# ICC A117.1 Committee Action Report

Proposal list to the 2017 A117.1 for the 2023 edition –  
2-24-2022 through 1-19-2023  
Chapter 6 to 11

## ICC A117.1 Committee Action Report Chapter 6

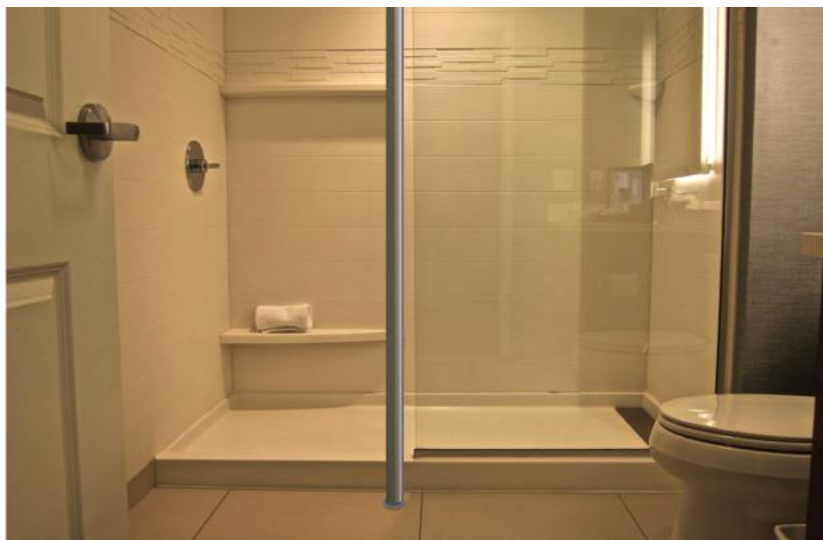
This augmented photo illustrates the possible dilemma over such vertical stanchion placement. Is it too close to the seat; is it too far from the seat (like the water controls are), or is it just right? The proposal is open to all options on this matter (keeping in mind the value of the stanchion also serving the water closet as set out in proposed new Section 604.12 in which the performance requirement of a 28-inch reach distance is utilized.) The 28 inches is based on a reachability analysis as well as being explained and illustrated in Appendix A to this proposal). Note also a second vertical stanchion digitally added at the vanity side serving the water closet.

**Figure 604.9.3(B)**  
**Wheelchair Toilet Compartment Doors**  
**Exception 3 – Alternate Wheelchair Compartment**

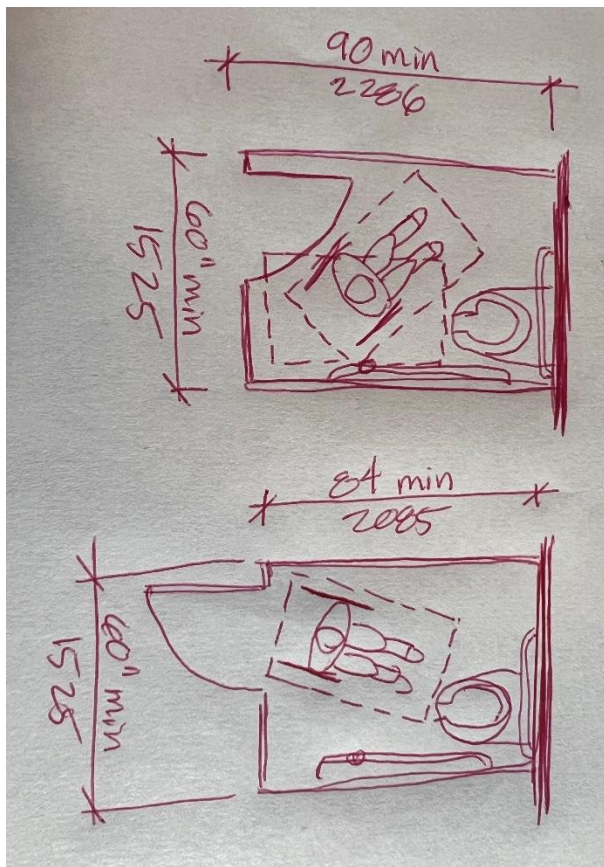
2. Within the wheelchair accessible toilet compartment, maneuvering clearances at the door shall not be required to comply with Section 404.
3. In an alternate wheelchair accessible toilet compartment, the door shall be permitted to swing into the stall compartment where the minimum depth of the stall is 90 inches (2286 mm) a clear floor space complying with Section 305.3 is provided within the stall beyond the arc of the door swing.

This proposal ties and limits the third exception directly to the alternate compartment provisions of Section 604.9.2.3 and ensures that the door is located to allow a user to move straight into the stall. Without a limitation for the door to be located in the front wall (as was the original intent), Section 604.9.3.1 could be used to allow a side wall door. Again the original proponent and the committee were expecting the door for the “alternate” compartment to be located as shown in Figure 604.9.3(B) and to allow the user to move directly into the compartment and to allow a forward approach to the water closet.

**FIGURE 607.3**  
**CLEARANCE FOR BATHTUBS CONTROLS**

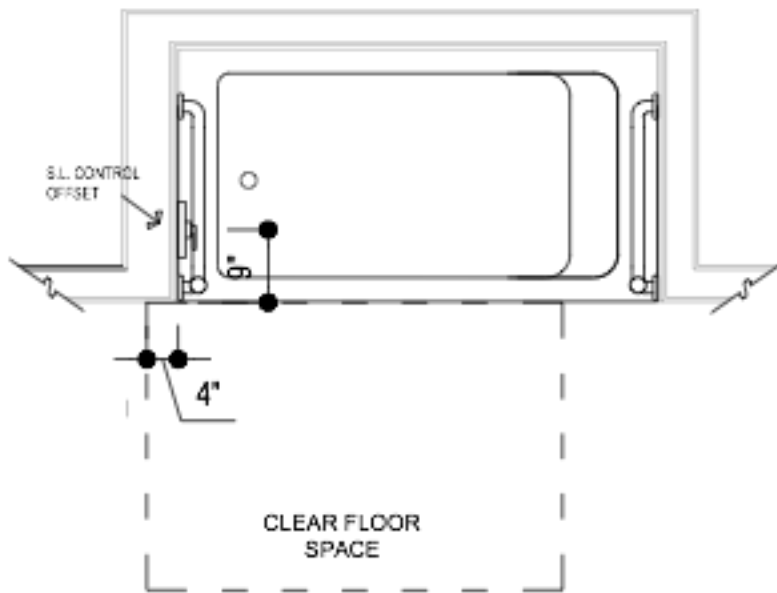
*Note: The wall in the Figures 607.2(A) and 607.2(B) would be jogged to indicate the additional 4 inch toe clearance in the new Figure 607.3. The committee will need to decide if Figures 607.2(A) and 607.2 (B) should be revised to show the control clearance with the transfer clearance or if the control clearance should be in a separate Figure 607.3. The figure submitted indicates the transfer clearance moving forward, not an addition 4 inch control clearance as the text indicates.*

**607.3 Control Clearance.** The clear floor space for toe clearance at the controls shall extend 4 inches (100 mm) minimum beyond the control end wall.

**FIGURE 607.3**  
**CLEARANCE FOR BATHTUBS CONTROLS**

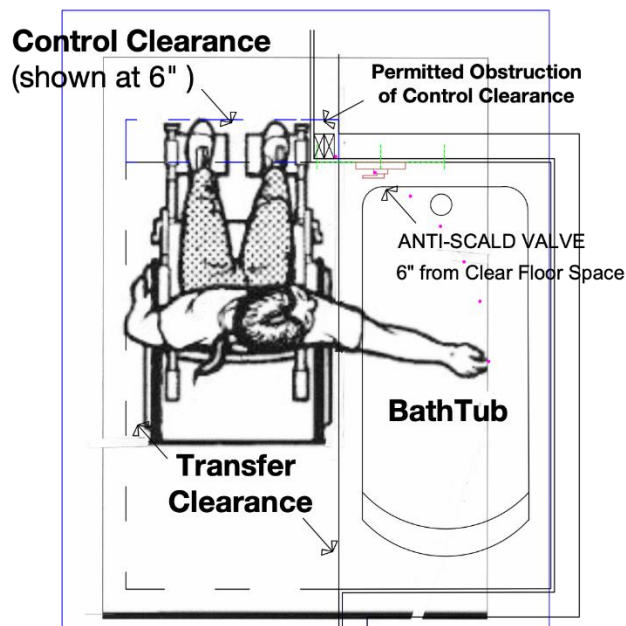
**607.3 Control Clearance.** The clear floor space for toe clearance complying with Section 306.2 at the controls shall extend 6 inches (152 mm) minimum beyond the control end wall. An obstruction by the control wall of 4 inches (102 mm) maximum shall be permitted.

*Note: The wall in the Figures 1103.11.2.5.1(A) and 1103.11.2.5.1(B) would be jogged to indicate the additional 6-inch control clearance in the new Figure 607.3*

**FIGURE 607.3  
CLEARANCE FOR BATHTUBS CONTROLS**

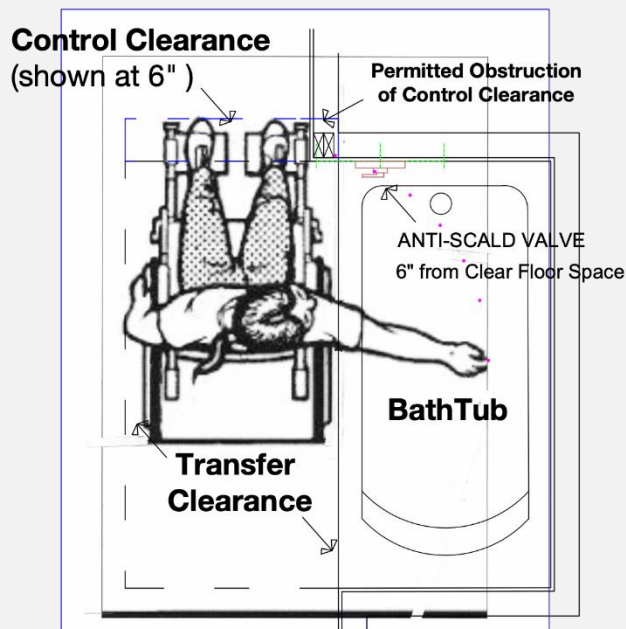
**Exception:** The control wall shall be permitted to overlap the clear floor space 4 inches (102 mm) maximum measure horizontally from the outside face of the bathtub.

Figure 607.4.2(A) Grab Bars for Bathtubs with Removable In-tub Seats – Elevation  
*Note – seat would have to move forward in graphic*

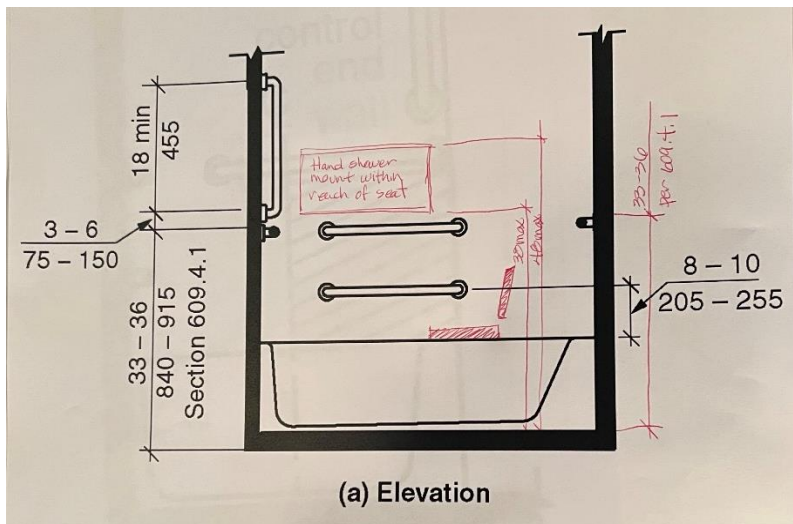
**607.4.2 Bathtubs with removable in-tub seats.** For bathtubs with removable in-tub seats, grab bars complying with Section 607.4.2 shall be provided.

Figure 607.4.2(B) Grab Bars for Bathtubs with Removable In-tub Seats - Plan  
*Note – seat would have to move forward in graphic*

**FIGURE 610.2(A) 610.2.1  
BATHTUB SEATS  
REMOVABLE IN-TUB SEATS**

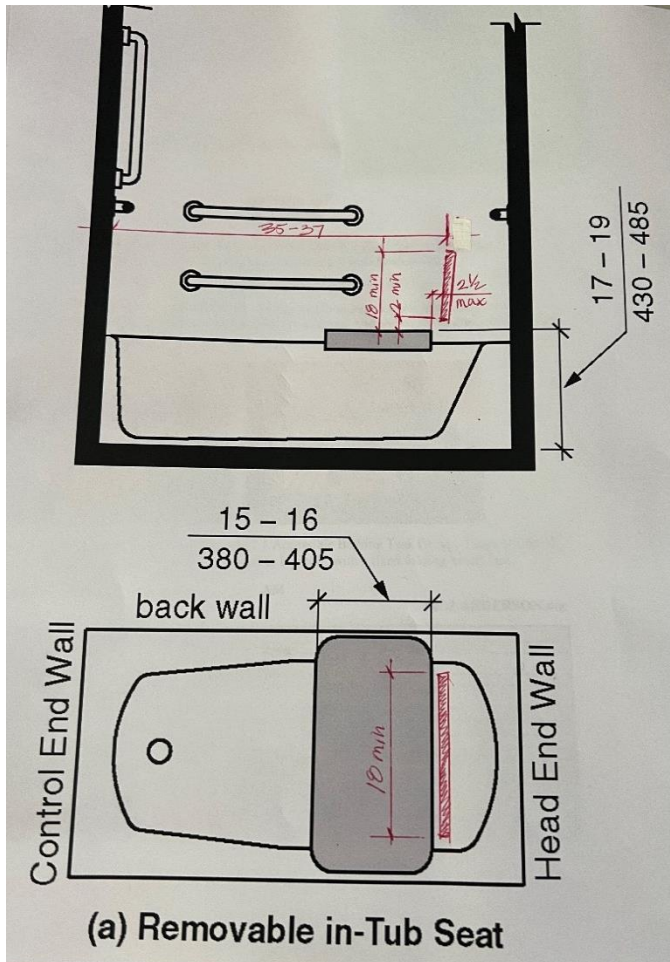
**610.2.1 Removable in-tub seats.** Removable in-tub seats shall be 15 inches (380 mm) minimum and 16 inches (405 mm) maximum in depth. The seat shall provide back support with the top edge of the back support 18 inches (455 mm) minimum above the seat surface. Removable in-tub seats shall be capable of secure placement with the rear edge of the seat surface positioned 36 inches (914 mm) maximum from the control wall.

**FIGURE 610.2(B) 610.2.2**

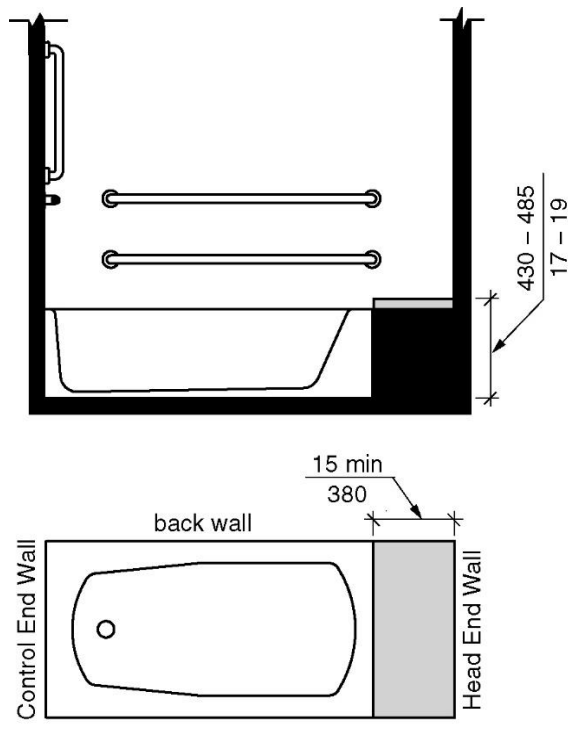
**610.2.2 Bathtubs with transfer platforms.** ~~Permanent seats~~ Transfer platforms shall be 15 inches (380 mm) minimum in depth and shall extend from the back wall to or beyond the outer edge of the bathtub. ~~Permanent seats~~ Transfer platforms shall be positioned at the head end of the bathtub.

**FIGURE 607.4.3(B)**  
**GRAB BARS FOR BATHTUBS WITH FIXED FOLDING IN-TUB SEATS –PLAN**

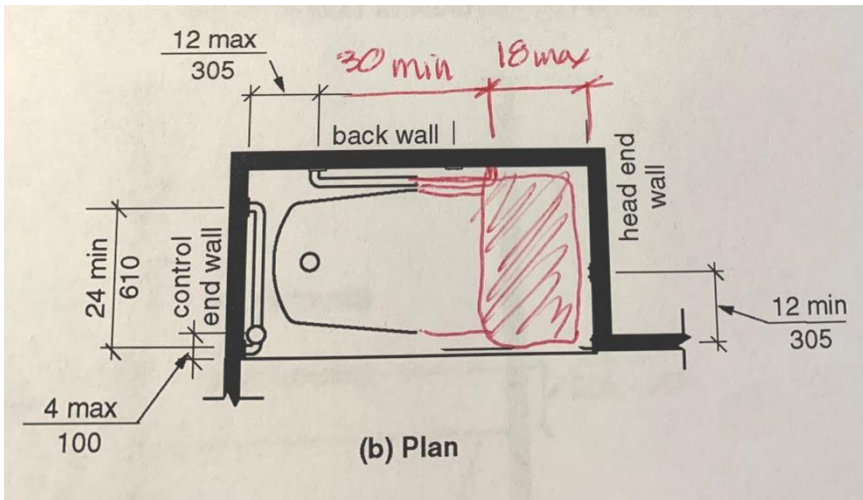
**FIGURE 607.4.3(A)**

**GRAB BARS FOR BATHTUBS WITH FIXED FOLDING IN-TUB SEATS – ELEVATION**

**FIGURE 607.4.3(A)**  
**GRAB BARS FOR BATHTUBS WITH FOLDING IN-TUB SEATS – ELEVATION**

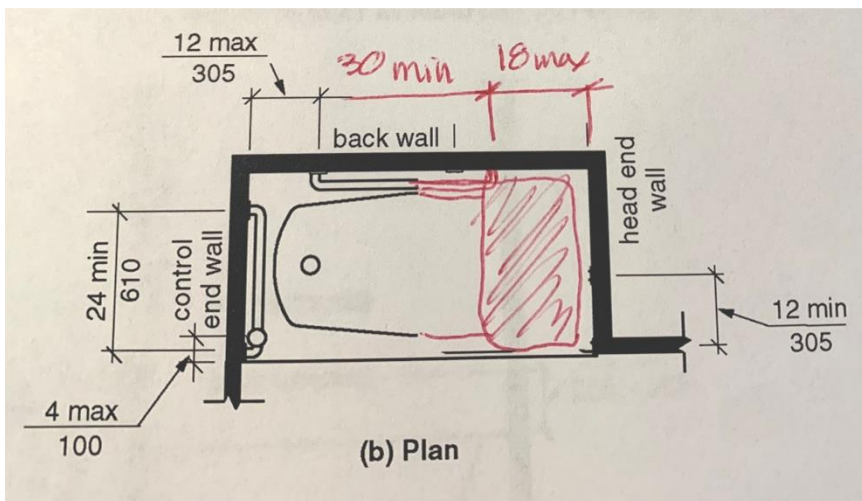
**FIGURE 607.4.3(B)**

**FIGURE 607.6.2**  
**LOCATION OF MOUNT FOR BATHTUB WITH FOLDING SEAT**

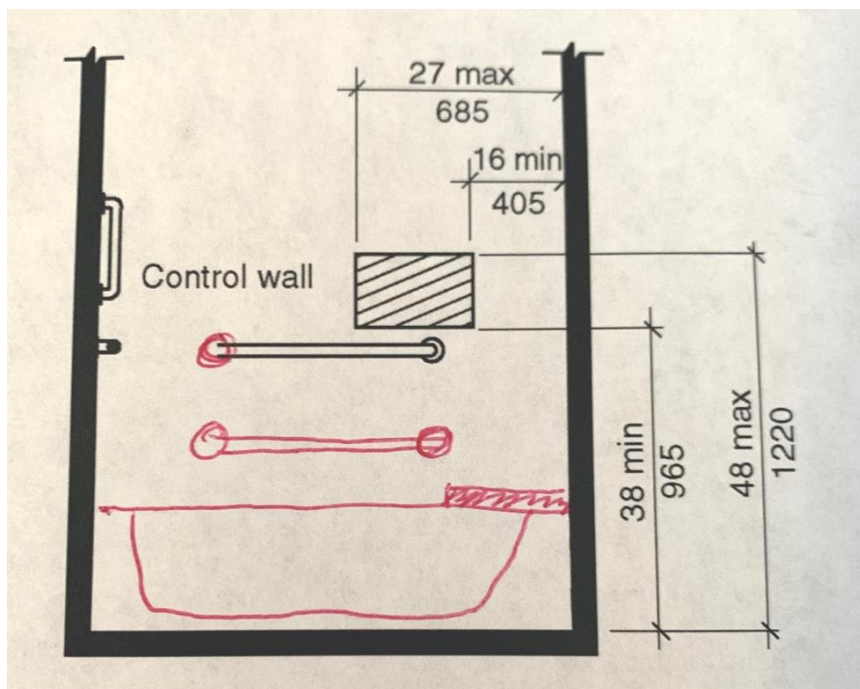
**Exception:** The mount to hold the hand shower shall be permitted to be located on a vertical bar provided that the mount is adjustable in height and can be located within the area specified for the fixed mount.

**FIGURE 610.2.3**  
**BATHTUB SEATS**  
**FOLDING IN-TUB SEAT PROVIDED AT HEAD END OF TUB**

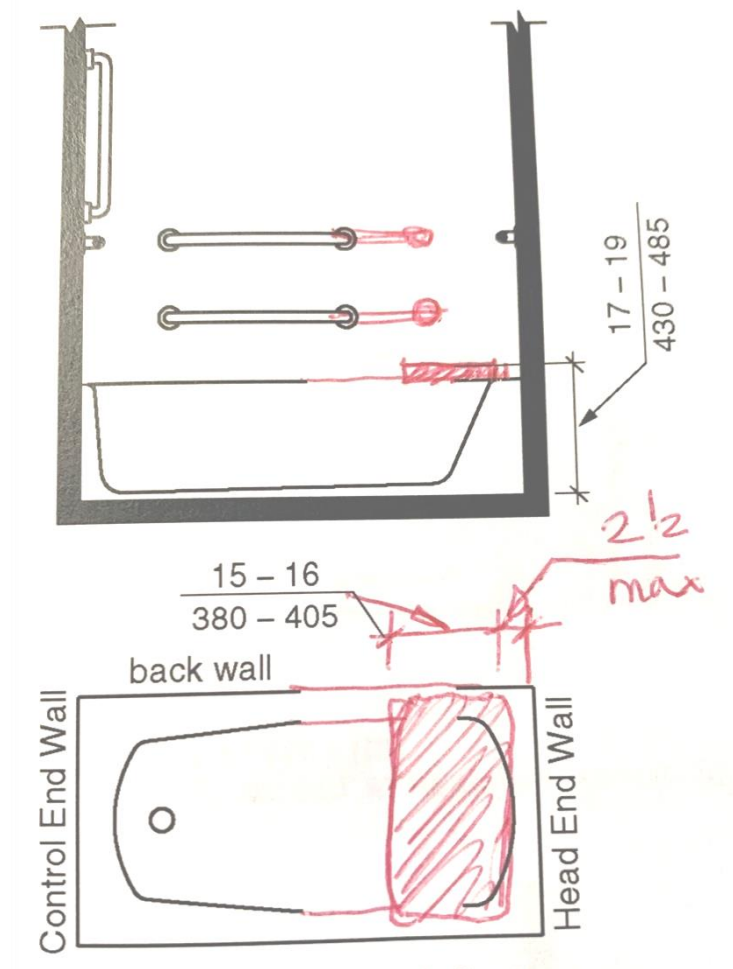
**610.2.3 Folding in-tub seats.** Folding in-tub seats shall be mounted on the head wall. The rear edge of a seat shall be 2-1/2 inches (64 mm) maximum and the seat shall be 15 inches (380 mm) minimum and 16 inches (405 mm) maximum in depth. The side edge of the seat shall be 1-1/2 inches (38 mm) maximum from the back wall.

**FIGURE 607.5.1**  
**LOCATION OF BATHTUB CONTROLS ON BACK WALLS**

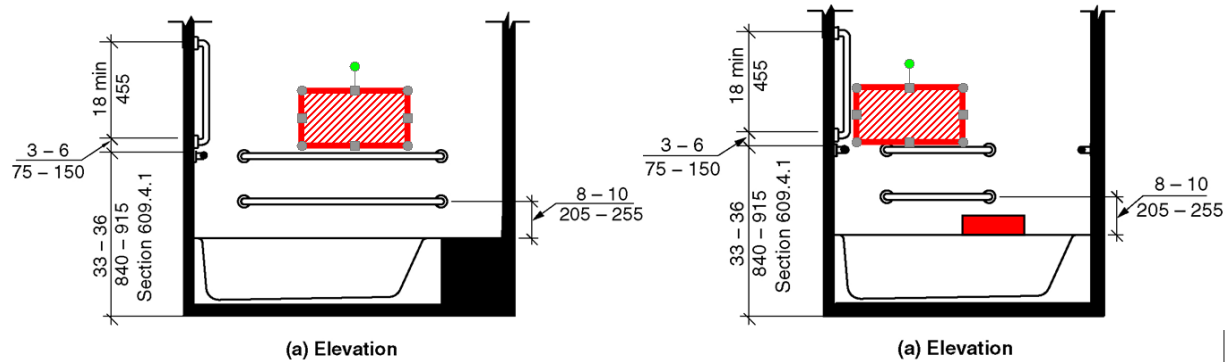
*Note: Add two new figures with dimensions to match text for rear wall controls.*

**FIGURE 607.5.1**  
**LOCATION OF BATHTUB CONTROLS DIVERTERS AND MOUNTS ON BACK WALLS**

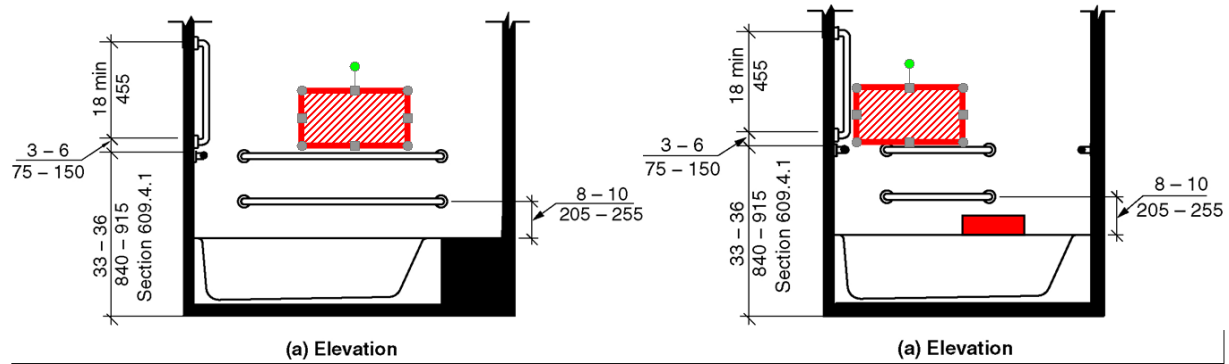
*Note: Add two new figures with dimensions to match text for rear wall controls.*

**FIGURE 608.4.3(C) ALTERNATE ROLL-IN-TYPE SHOWER HAND SHOWER MOUNT LOCATION - END WALL – ELEVATION**

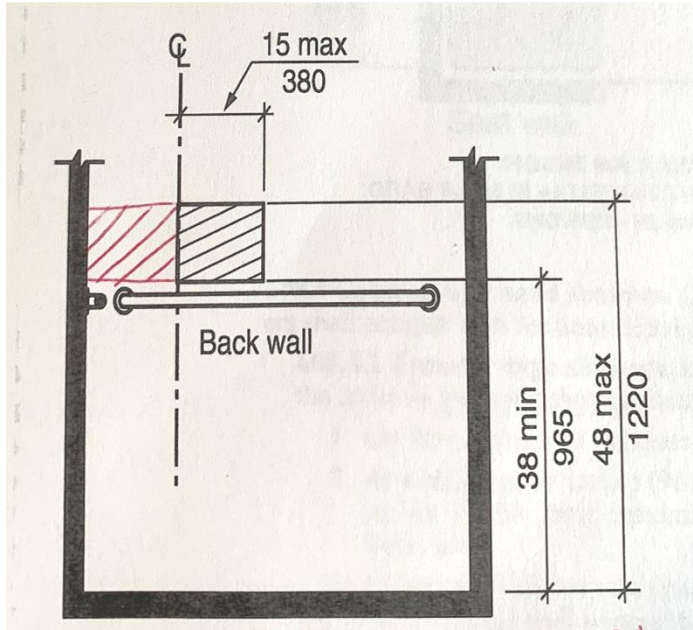
**Exception:** The mount to hold the hand shower shall be permitted to be located on a vertical bar provided that the mount is adjustable in height and can be located within the area specified for the fixed mount.

**FIGURE 607.5(B)**  
**EXCEPTION-LOCATION OF DIVERTER FOR BATHTUB WITH FIXED FOLDING IN-TUB SEAT**

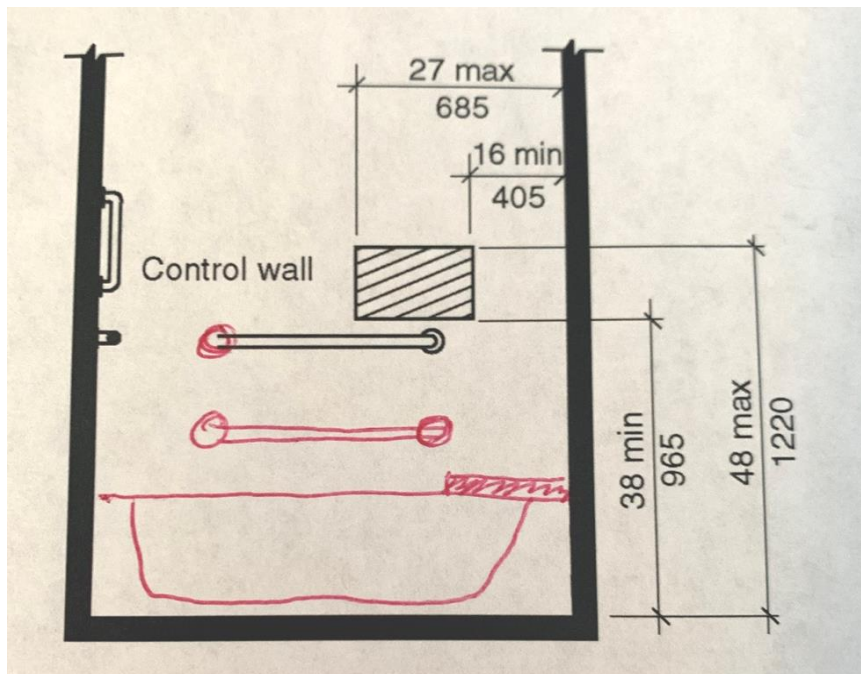
### 607.5, 607.6, Figure 607.5(B)(New)
